Photograph 1997-14-U

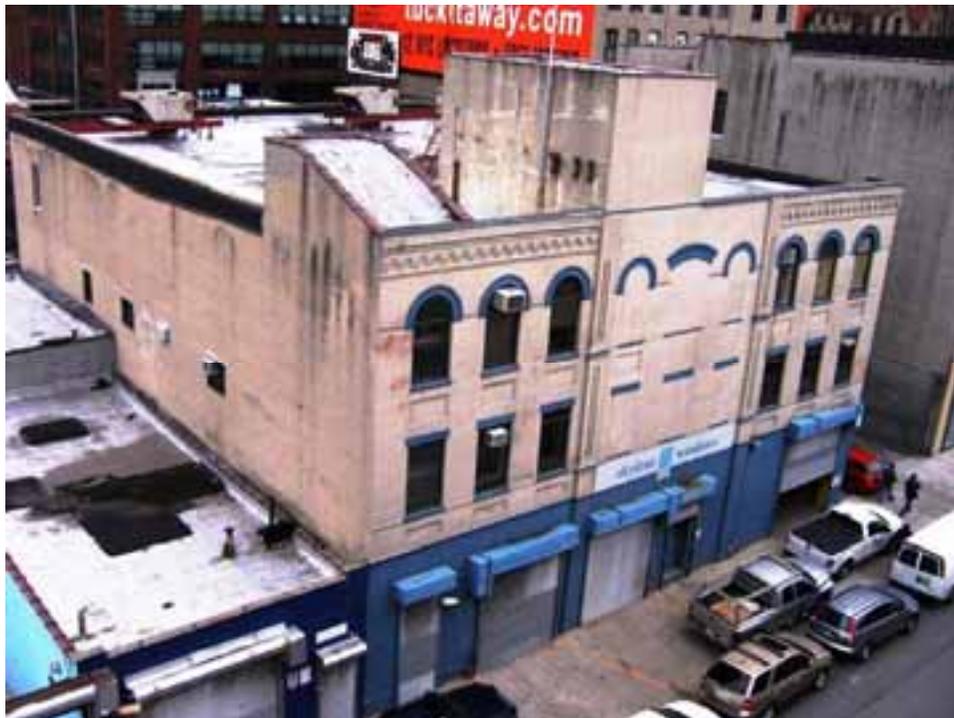
5. Water stains on ceiling (see photo N)
6. Spalling and cracking of west stair's concrete treads (see photo R)
7. Cracked and spalled stucco on chimney (see photo O)
8. Basement floor has numerous cracks. (see photos P and Q)
9. Ponding continues to occur on roof. (see photo S and T)
10. Lower roof is completely covered with moss (see photo U)
11. Sidewalks along West 130th street are in fair condition. Trucks continue to use the sidewalk as a parking area. (see photo V)
12. Staining on first floor ceiling by garage entrance. Possibly from fire damage. (see photo W)
